Notice of a Meeting
Dalworthington Gardens Planning and Zoning Commission

April 3, 2025 at 6:00 p.m.

3. Approval of Minutes
 - i. 2.6.2025 Minutes
4. Discussion and possible recommendation on an application for a preliminary plat submitted by Aldridge Building Corp for Lot 19, Block A, 1.001 acres of land located in The Joseph Pierce Survey, Abstract No. 1253 an addition to the City of Dalworthington Gardens, Tarrant County, Texas, and locally known as 3815 Kelly Perkins Road.

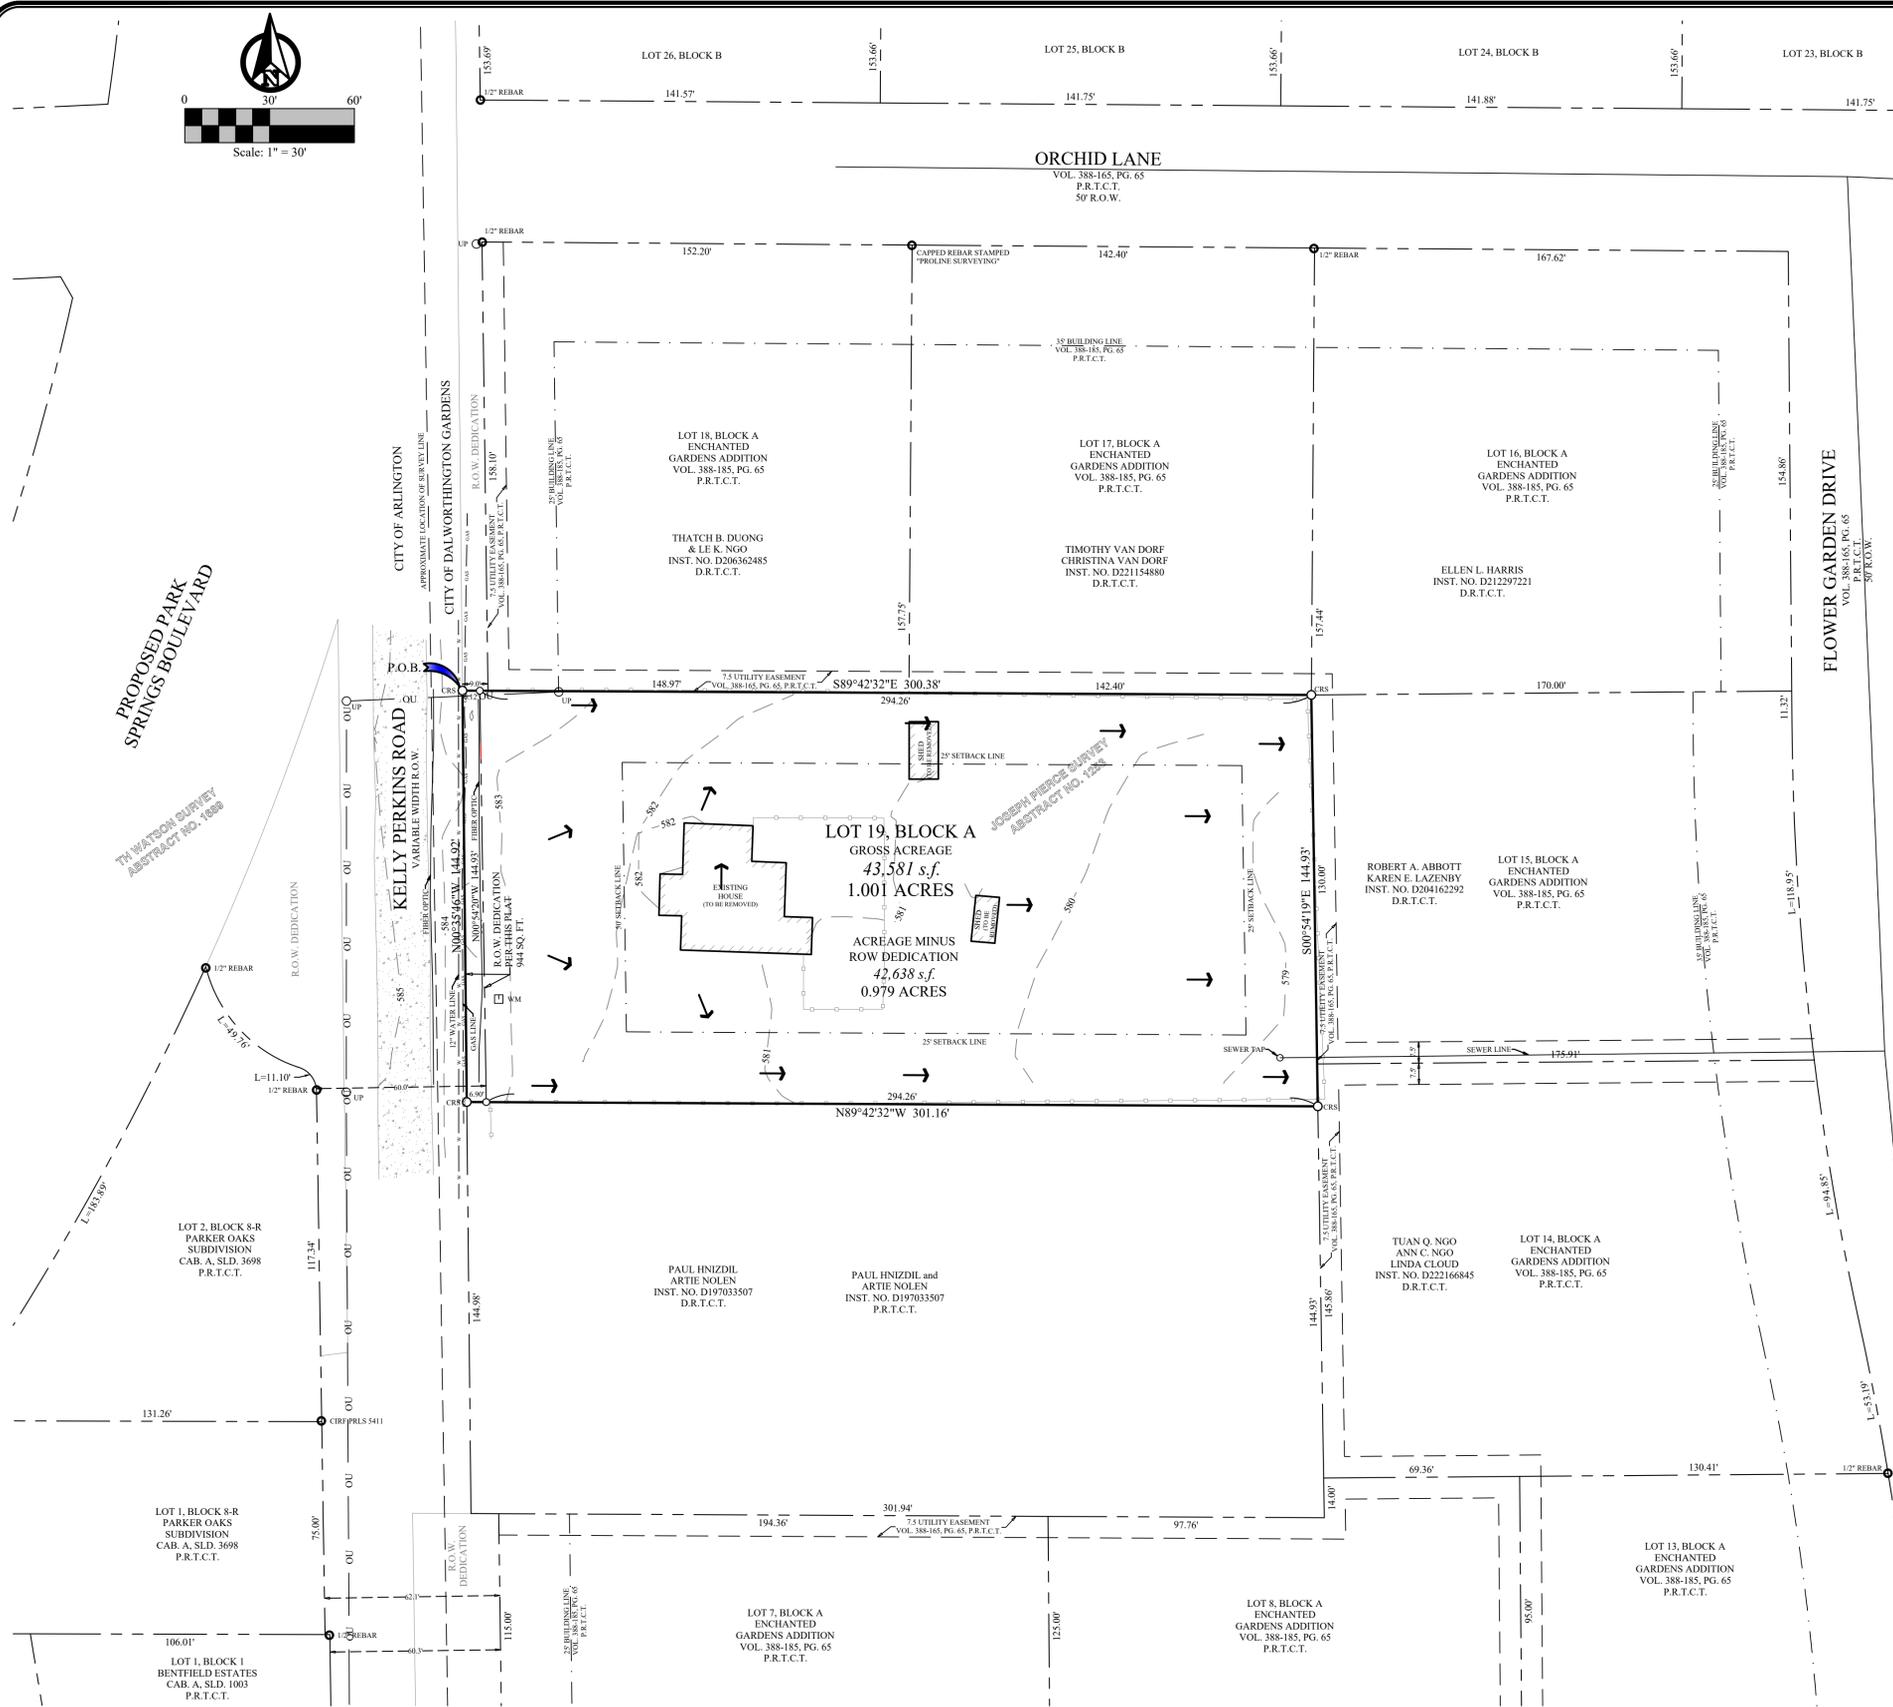
- 1) Show and label all existing utilities on and adjacent to the property and label the line sizes. **Partially addressed. Label the sanitary sewer line sizes for the lateral that extends to the property and for the main in Flower Garden Drive.**
- 2) Provide a preliminary drainage plan to show how the property will drain. **Not addressed. The preliminary drainage plan shall be a separate exhibit that shows the proposed improvements and proposed grading.**
- 3) Any major proposed changes in topography shall be shown by labeled contour lines. **Not addressed. If there are major proposed changes in topography that are shown on the preliminary drainage plan, these will need to be included on the face of the plat.**

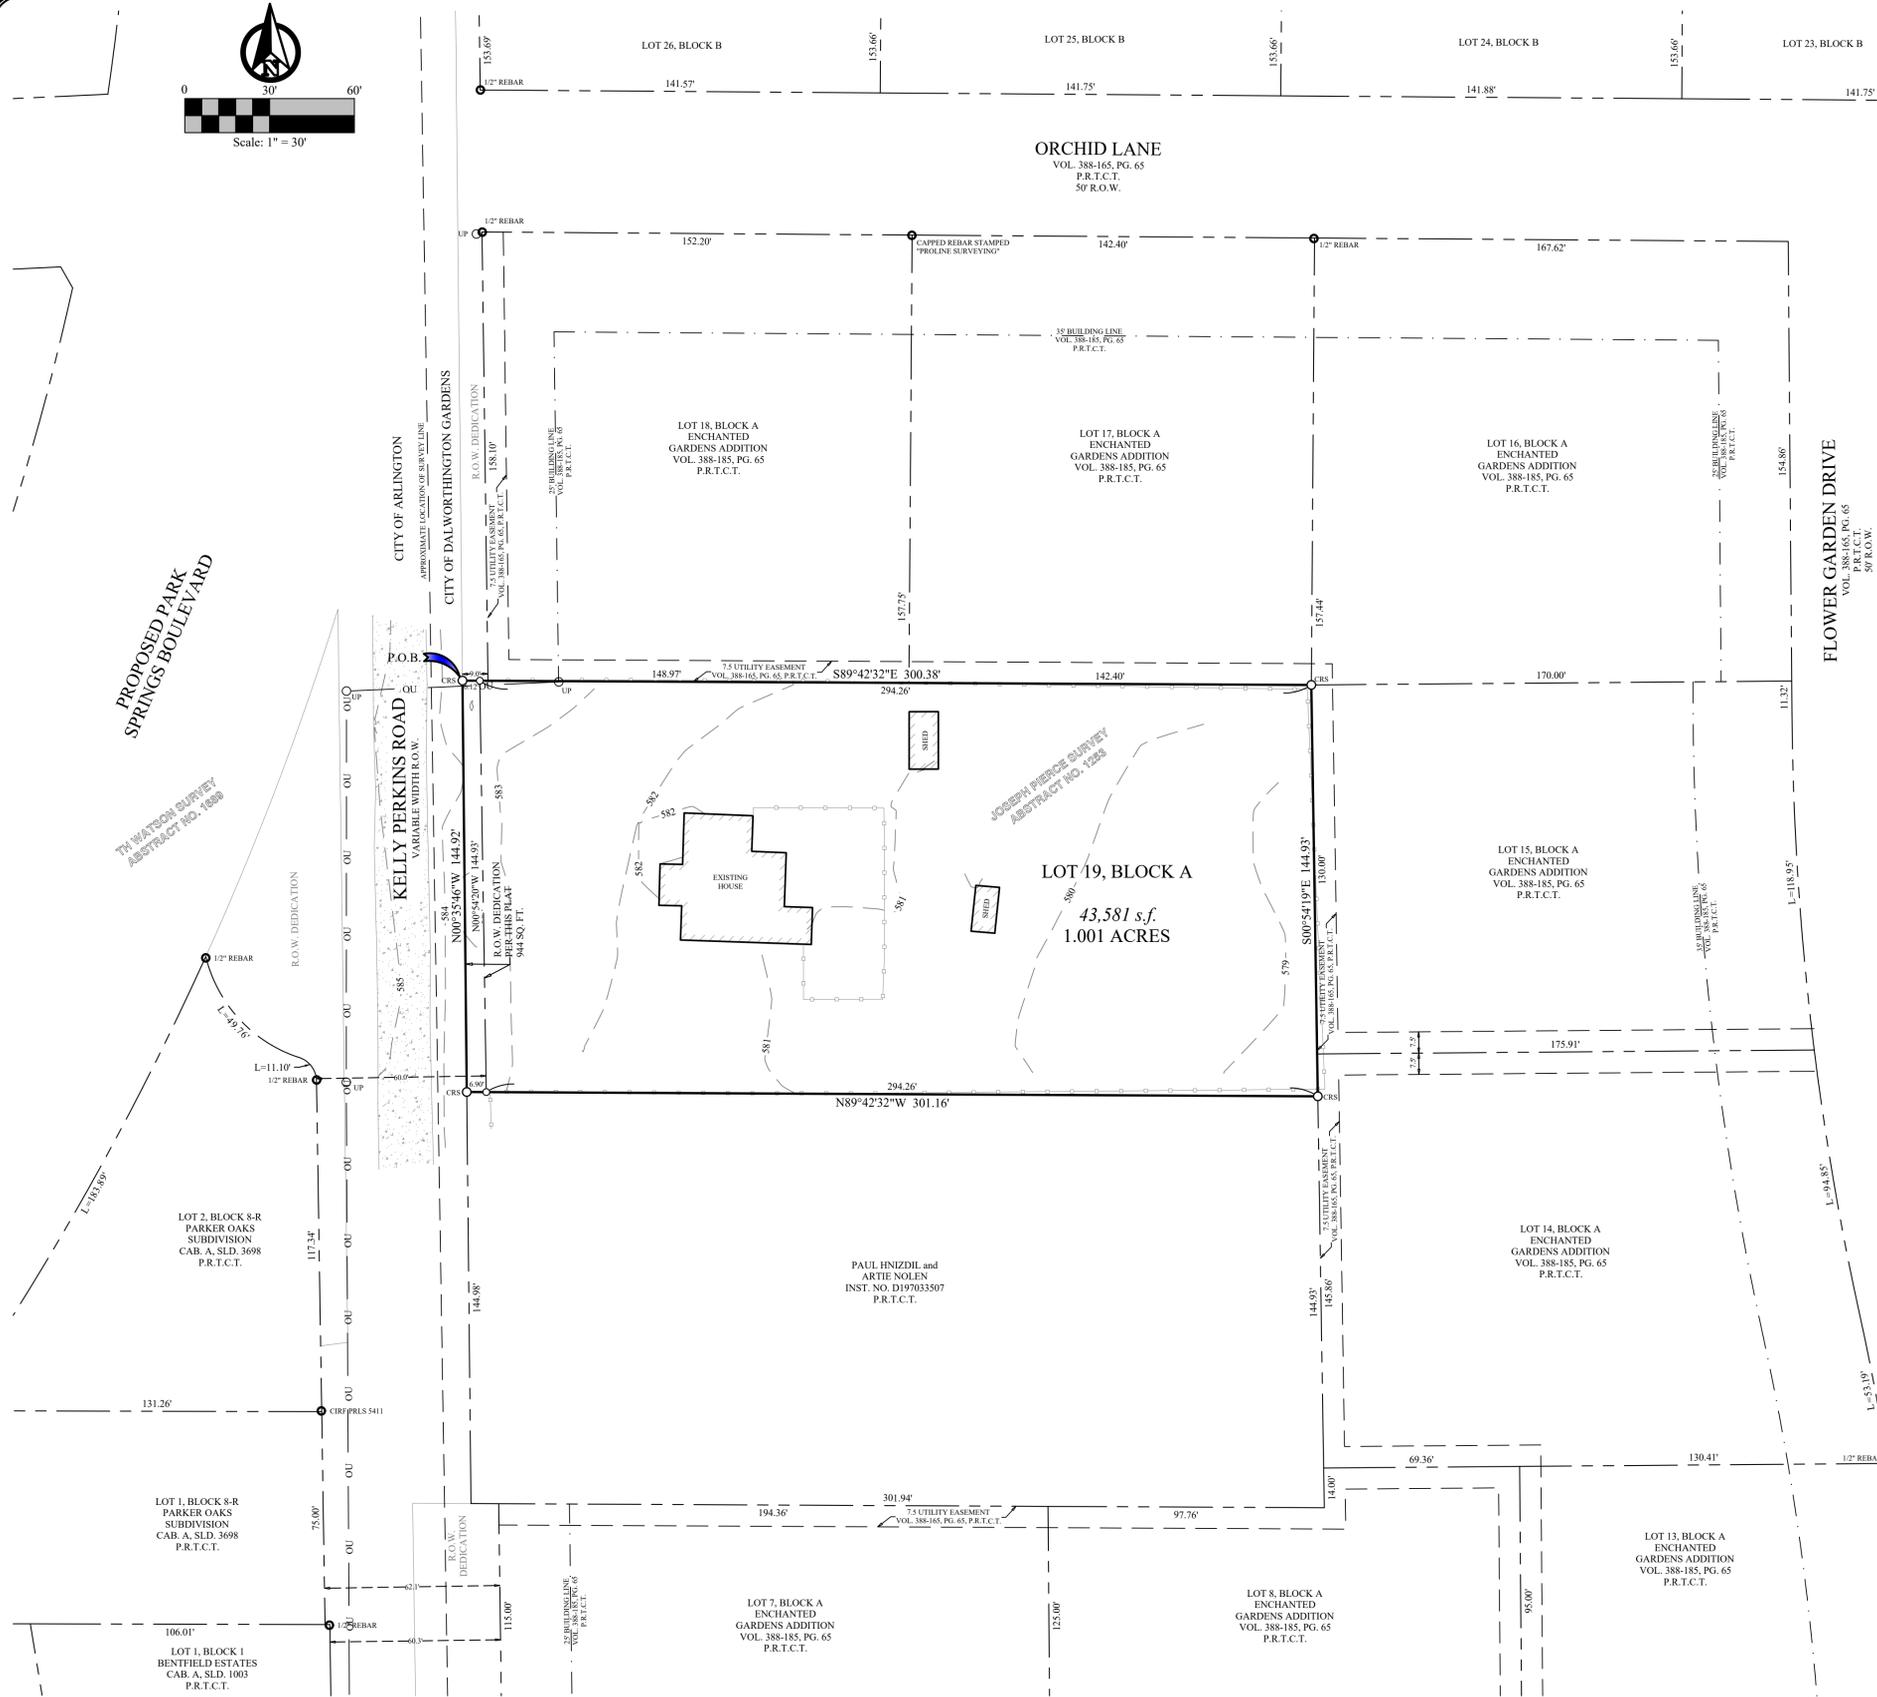
- 1) Revise the name of the plat to be only “Preliminary Plat”.
- 2) Add a note stating that the maximum building coverage of the lot shall be 25%.
- 3) Add a note stating that the maximum impervious coverage of the lot shall be 40%.

- 4) Accessory buildings such as shed cannot be within the building setbacks. Label all existing structures as either to remain or to be removed.
- 5) Show and label all existing utilities on and adjacent to the property and label the line sizes.

- 6) Provide a preliminary water and sewer exhibit that shows how water and sewer service will be provided to the lot.
- 8) Any major proposed changes in topography shall be shown by labeled contour lines.

- 9) Provide a preliminary drainage plan to show how the property will drain.
- 10) Renumber notes so that number 4 is not skipped.
- 11) Revise the “Owner’s Certificate” so that it matches the template provided as an attachment to Chapter 10 of the online Code of Ordinances.

- 12) Revise the “Surveyor’s Certificate” so that it matches the template provided as an attachment to Chapter 10 of the online Code of Ordinances.
- 13) Revise the “City Approval Statement” so that it matches the template provided as an attachment to Chapter 10 of the online Code of Ordinances. The preliminary plat shall use “City Secretary”

- 14) In note 7, add a reference to section 10.02.227 of the subdivision ordinance.
- 15) Remove note 3 and add the deed restriction certification statement provided as an attachment to Chapter 10 of the online Code of Ordinances.

- 1) Revise the name of the plat to be only “Final Plat”.
- 2) Remove the preliminary statement above the title block.
- 3) Add a note stating that the maximum building coverage of the lot shall be 25%.

- 4) Add a note stating that the maximum impervious coverage of the lot shall be 40%.
- 5) Remove topography and all existing fences, pavement linework, structures, utilities, etc.

- 8) Renumber notes so that number 4 is not skipped.
- 9) Revise the “Owner’s Certificate” so that it matches the template provided as an attachment to Chapter 10 of the online Code of Ordinances.

- 10) Revise the “Surveyor’s Certificate” so that it matches the template provided as an attachment to Chapter 10 of the online Code of Ordinances.
- 11) Revise the “City Approval Statement” so that it matches the template provided as an attachment to Chapter 10 of the online Code of Ordinances. The final plat shall use “Council” and “Mayor” instead of “City Secretary”.

- 12) In note 7, add a reference to section 10.02.227 of the subdivision ordinance.
- 13) Remove note 3 and add the deed restriction certification statement provided as an attachment to Chapter 10 of the online Code of Ordinances.

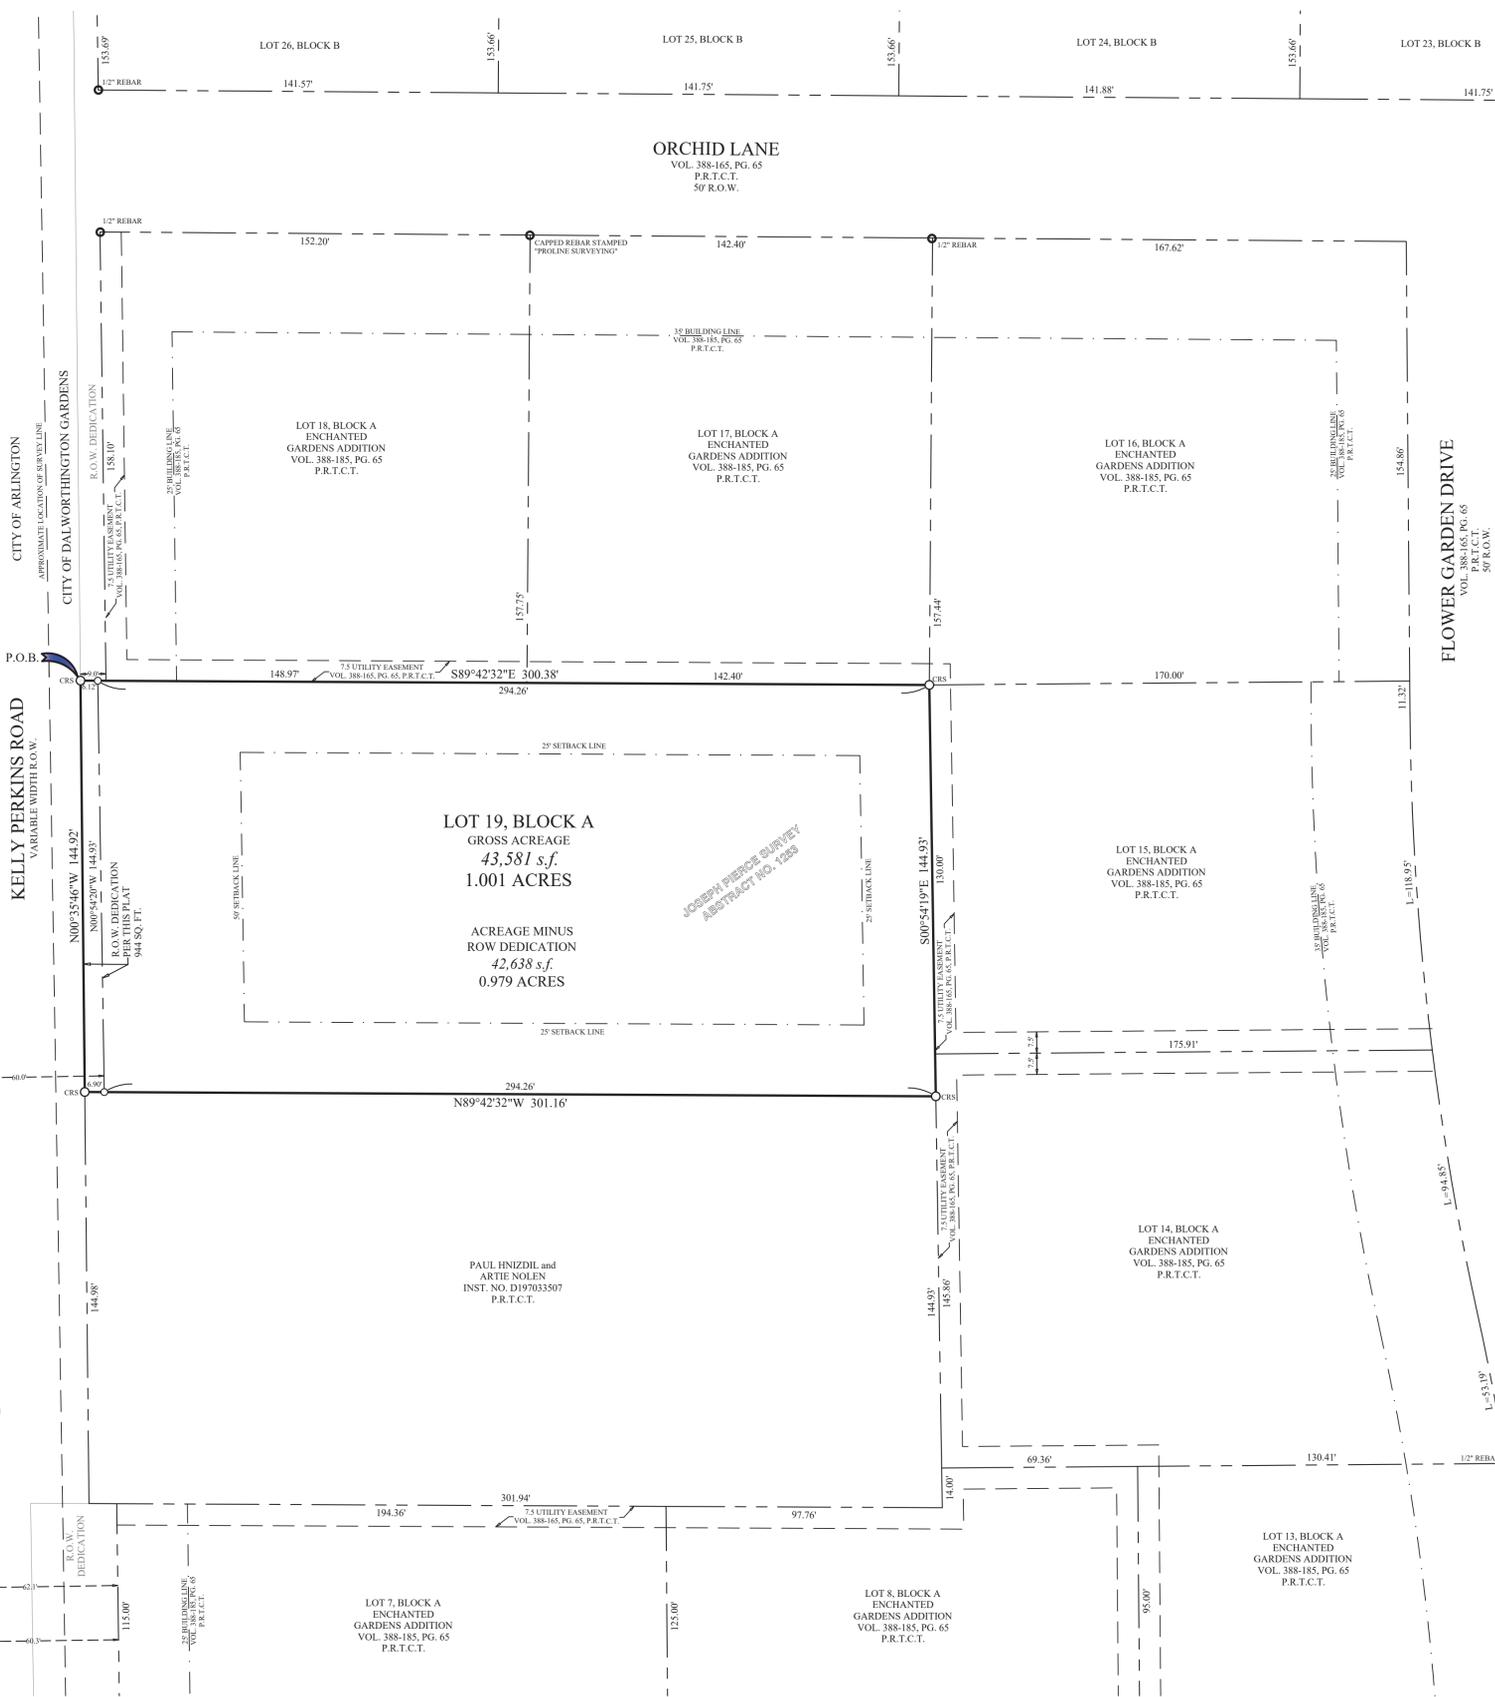
- 1) A preliminary plat must be approved prior to Final Plat approval.
